GEOCRES No. 3165-157

W.P. No. 11-81-05

Re: WP 11-81-05  
Service Road

RE: Jeanne D'Arc Boulevard Extension  
*W.P. 89-11002*, Site N/A  
District 9, Ottawa

FIGURE 2

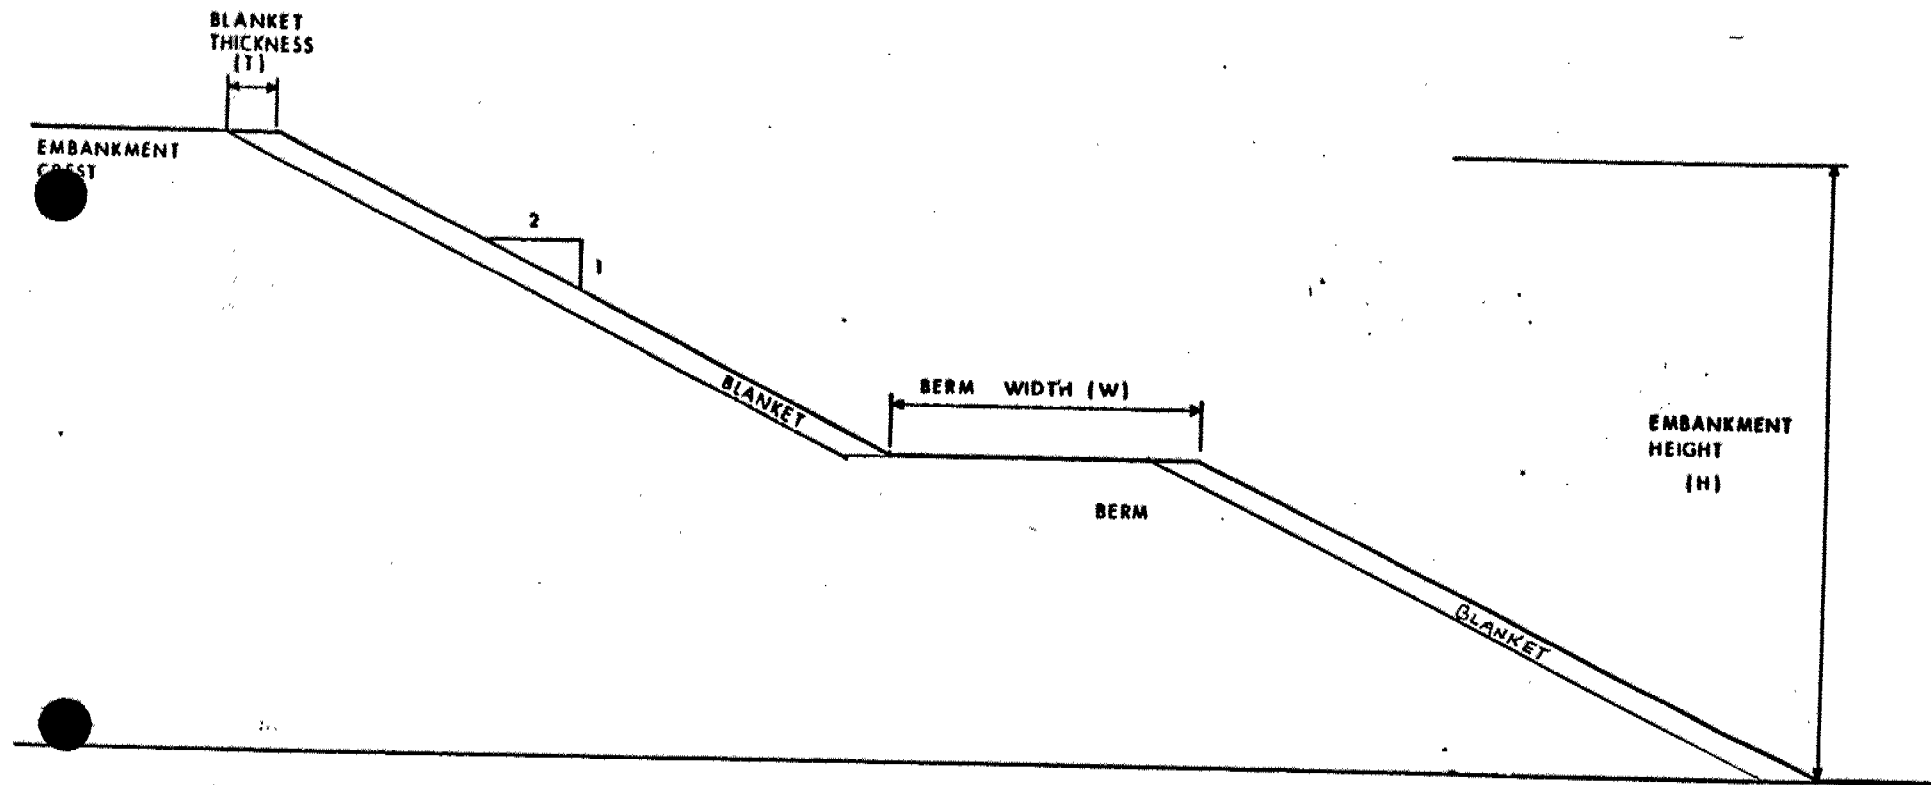
Stability analyses in terms of both total and effective stresses were carried out for typical embankment geometries for W.P. 11-81-01 (B) and have been referenced for embankment design at the Jeanne D'Arc Boulevard site. Based on these analyses, 2H:1V slopes up to 6 m high will be stable against deep-seated failure. For slope heights in excess of 6 m, berms will be required with widths as illustrated in Figure 1. If the embankments are constructed with cohesive material, the surface of the slopes should be treated with 1 m thick granular blankets consisting of rock fill or suitable free-draining granular material. This treatment is illustrated in Figure 2. These recommendations apply to both cuts and fills in excess of 3 m high.
